City of Sugar Hill  
Planning Staff Report  
VAR-20-005

DATE: August 31, 2020; **Updated 9/10/20**  
TO: Mayor and City Council  
FROM: Planning Director  
SUBJECT: Variance Request VAR-20-005  
Lidl US – Northwest corner Nelson Brogdon Boulevard and Sycamore Road

SHEET TITLE:  
**VARIANCE SITE PLAN**  
 SHEET NUMBER:  
**EX-2**  
 ORG. DATE - 07/27/2020

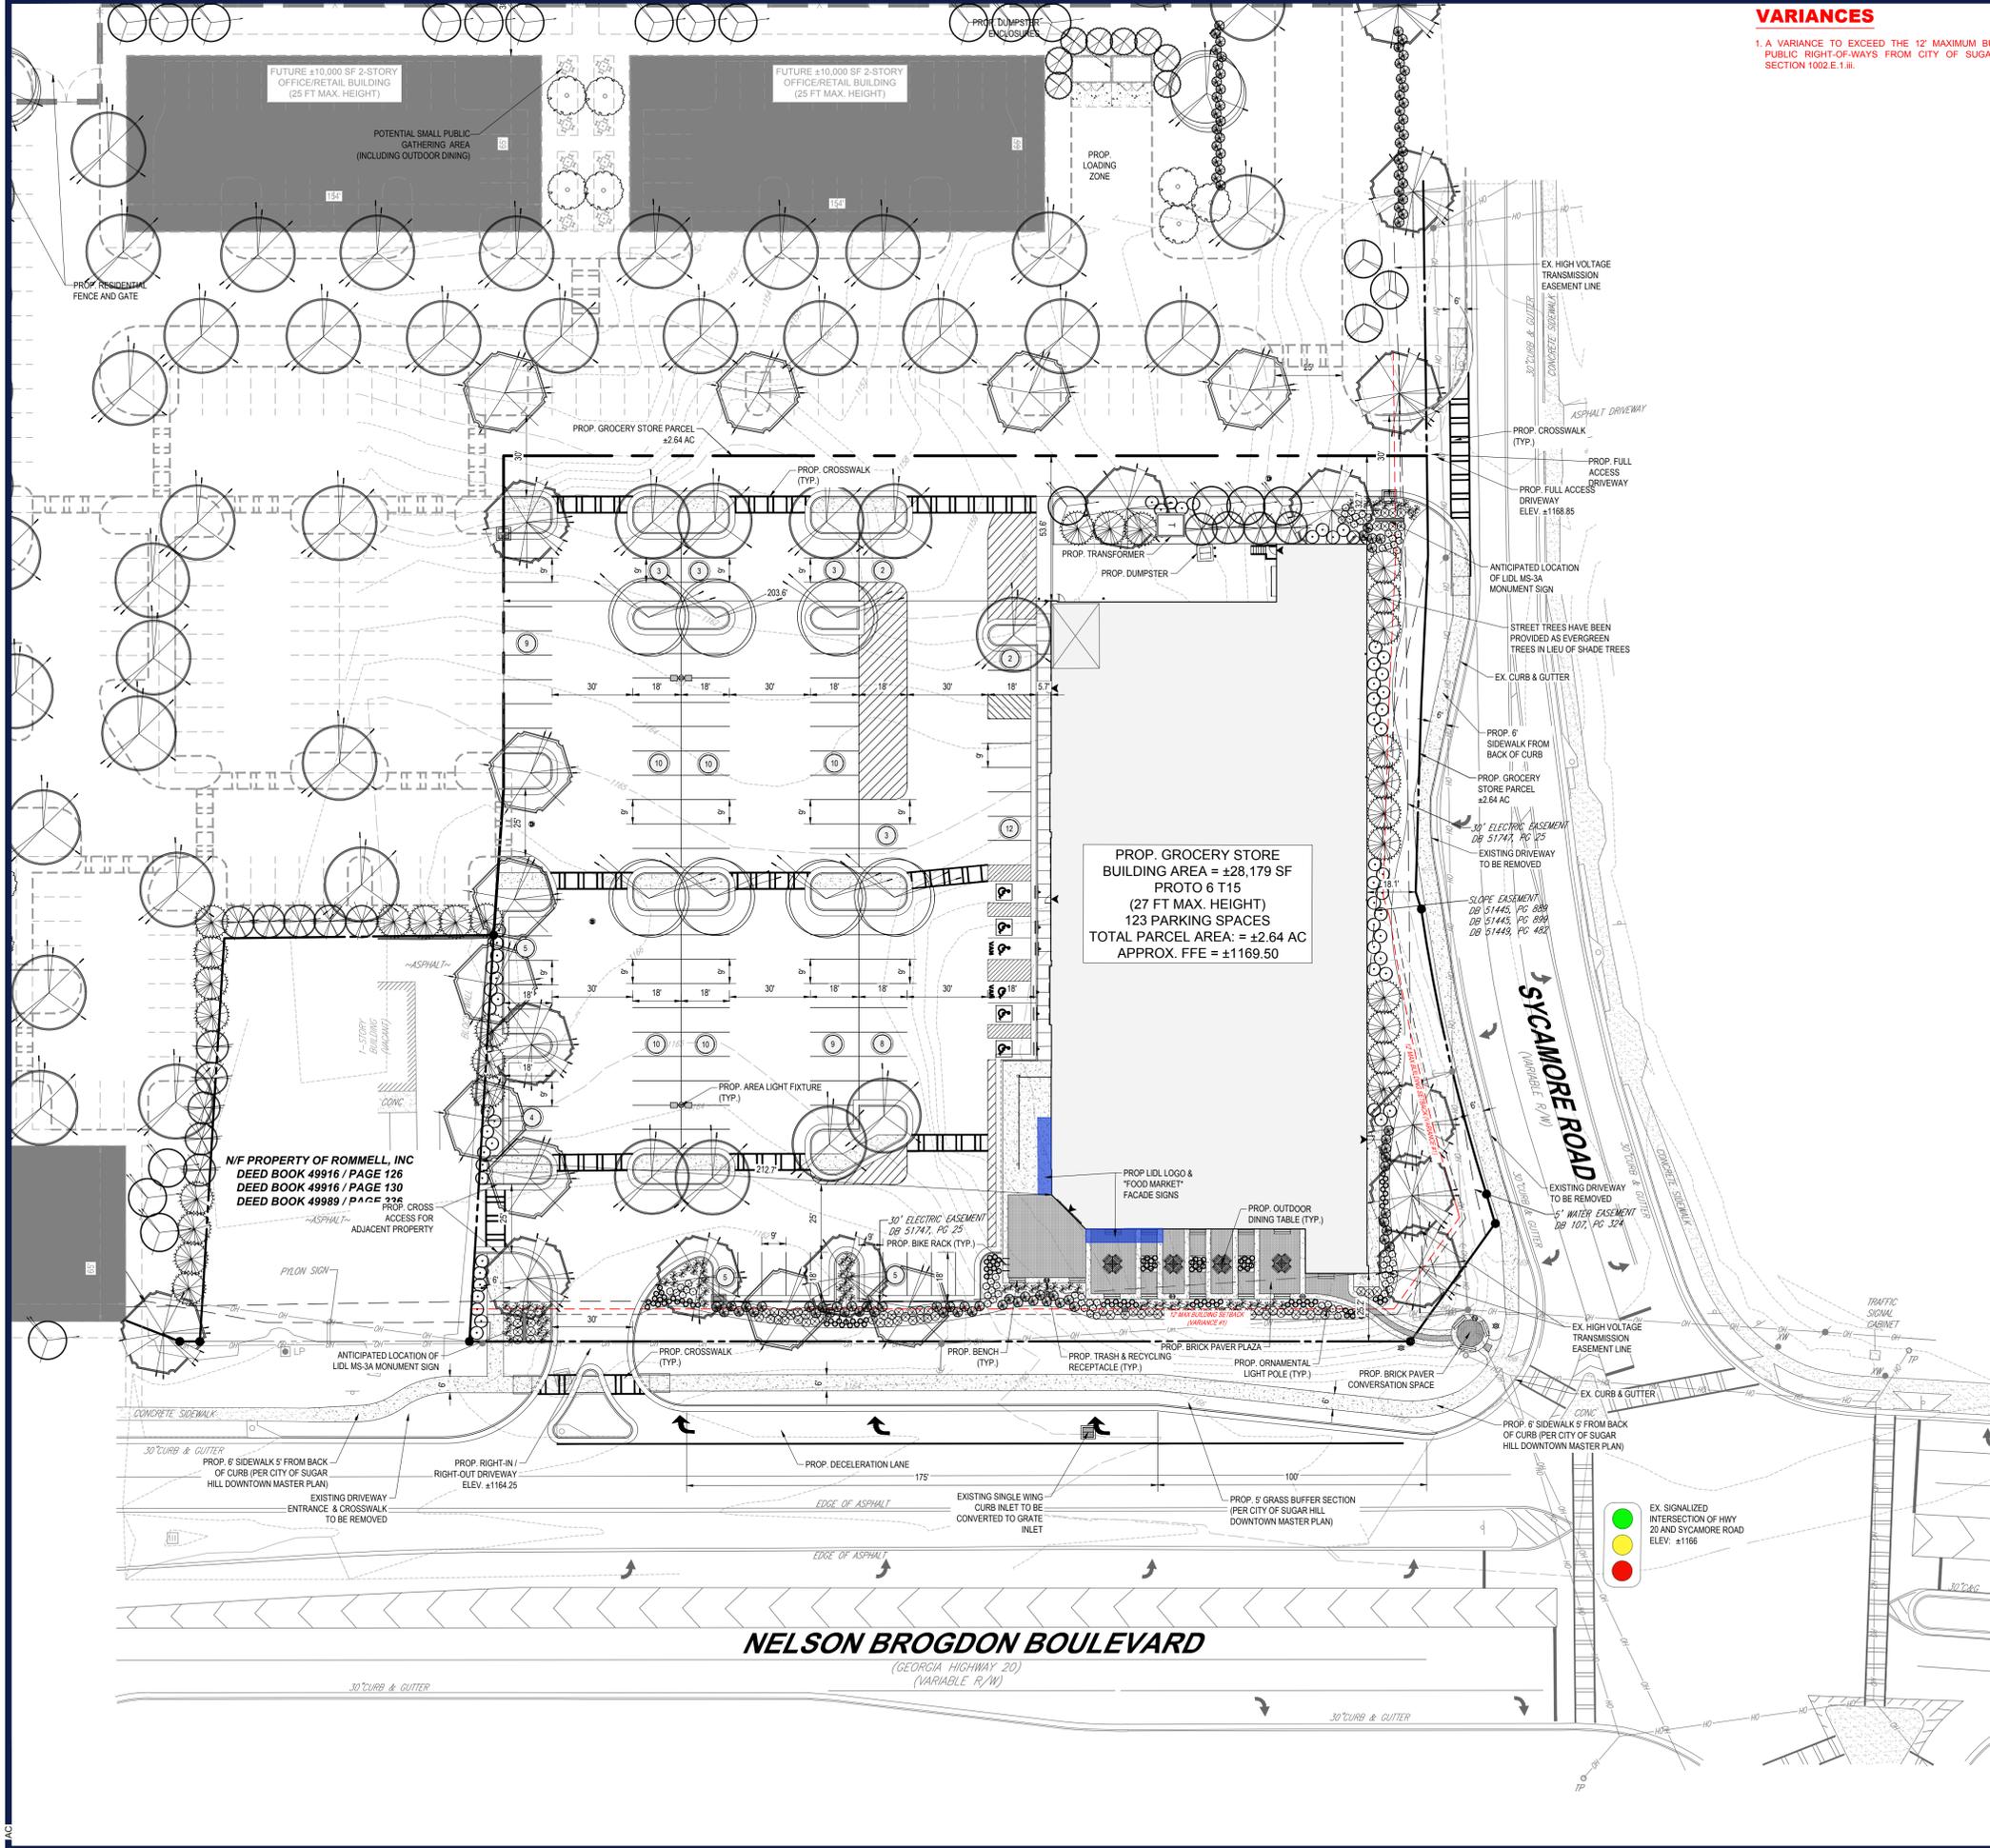
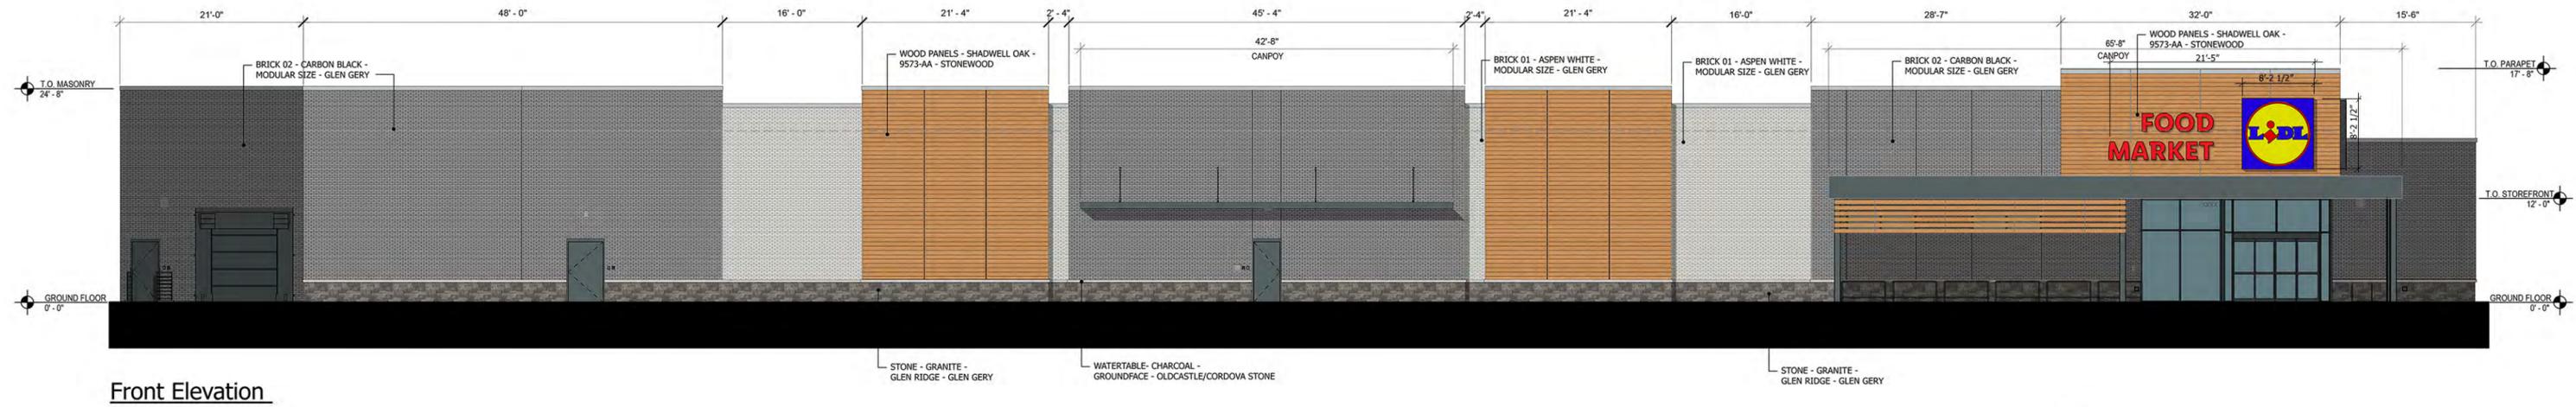
**Variance #1 (1002.E.1.iii):** Increase maximum setback from 12 feet to +/- 25.2 feet along Highway 20 to accommodate an existing high voltage transmission easement running along Highway 20 and additional landscaping along Sycamore Road.

Yes. The property contains a utility easement which prevents the placement of the building closer to the road (variance #1). Its distance from the adjacent streets and proximity to regional transportation corridor may affect the interpretation of variance #2 pertaining to maximum horizontal length of building segment. No other physical conditions of the property affect the application of design standards related to façade, fenestration, entry requirements and dumpster screening. (variances #3, #4 & #5).

Variances #1 and #2 dealing with the setback and building façade articulation are reconciled easily due to physical constraints of the site and commonly held design principles as explained above. However, Variances 3, 4 & 5 appear to be necessary only because of choices the grocery operator has made regarding their interior layout and operational preferences.

Approval with conditions for variances #1 and #2. Denial of variances #3, #4 and #5.

5. Landscaping along Sycamore Road shall be arranged to screen the building panels in no less than 20' increments. Landscape strip shall consist of at least two staggered rows of evergreen and semi-evergreen trees and shrubs native or adapted to the area. Trees shall be 6' tall at time of planting. Plantings shall be arranged to provide an effective visual screen of at least 20' in height at maturity. Landscape strip must not contain more than 1/3 of a single species and must be shown on a landscape plan to be approved by the city manager prior to receiving any permits.

Front Elevation

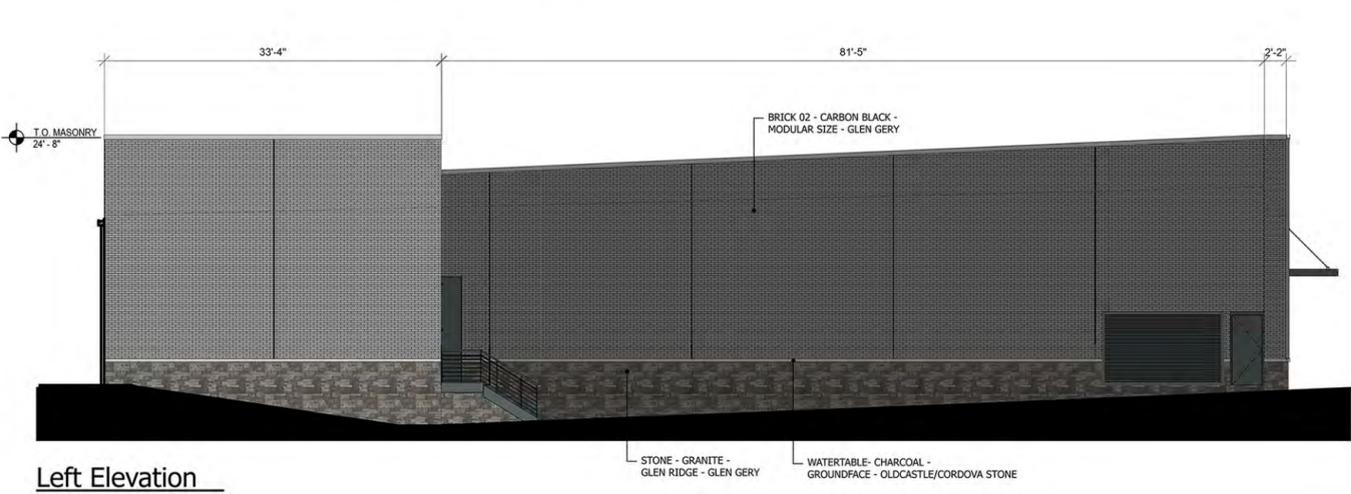
**Variance #4 (1002.E.3.vii):** Allow a single public entrance at the corner of the building nearest Highway 20 and the parking area.

The applicant is requesting that only a front building entrance be granted for this building. A grand plaza is provided near the front entrance, and having one entrance is beneficial to draw pedestrians to this area and help make it become an active, vibrant plaza. Pedestrian access from both streets are connected to this plaza and landscaping, benches, bike racks, and lights are provided at this proposed plaza. In addition, a rear entrance would be very disruptive to the internal layout of the store, as well as a security concern.

Right Elevation (facing Nelson Brogdon Blvd)

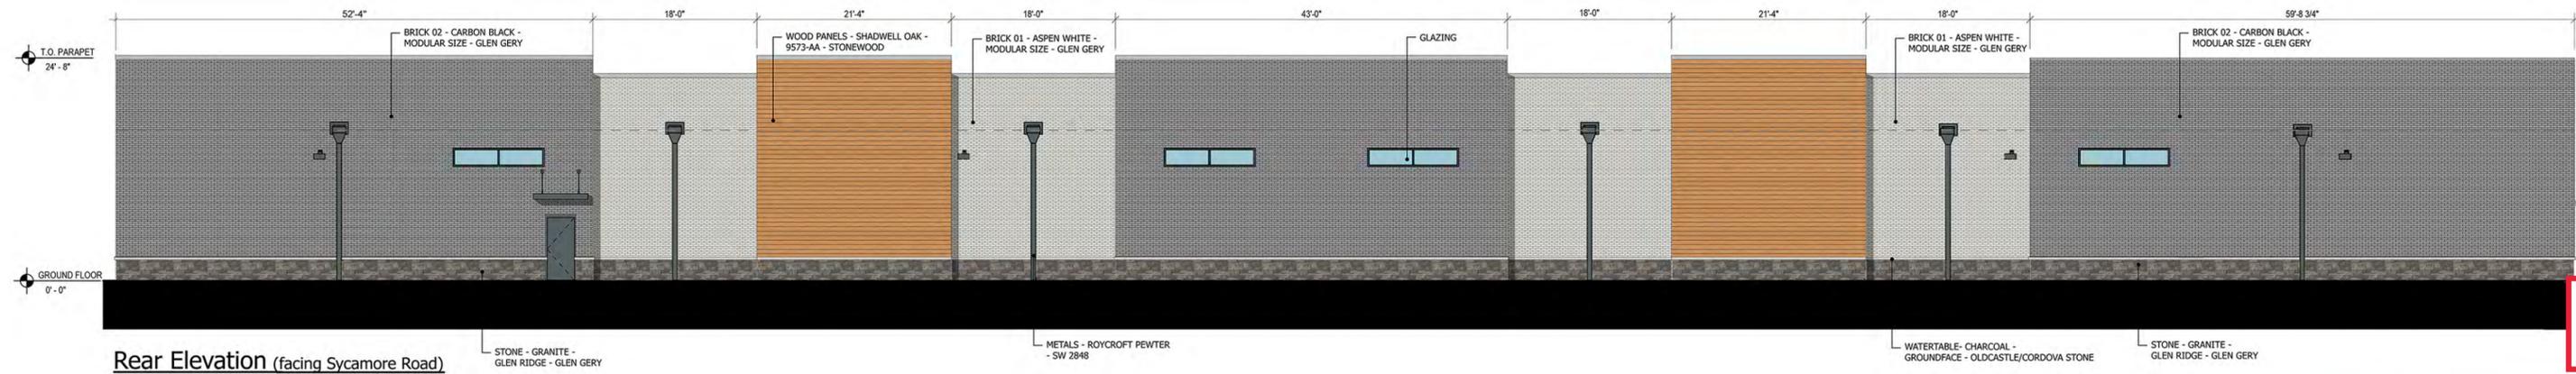
**Variance #3 (1002.E.2.iv):** Reduce 50% minimum transparency requirement for street-facing building facades.

The applicant is requesting that less than 50% transparency for the street facing façades be considered for this location. Due to the nature of the internal plan, the right façade, facing Highway 20, is just shy of the 50% and would require transparent windows in a restroom. This would cause a security and privacy concern. The back façade, facing Sycamore Road, has an internal layout of shelving and refrigerated cases along this façade. We have proposed some ribbon windows above the shelving and cases, as a concerted effort towards the transparency requirement and to help break up the façade, while also providing additional daylight into the sales floor. Another item of consideration is that this façade is heavily landscaped to achieve the density requirement and the façade will not be very visible from the street.
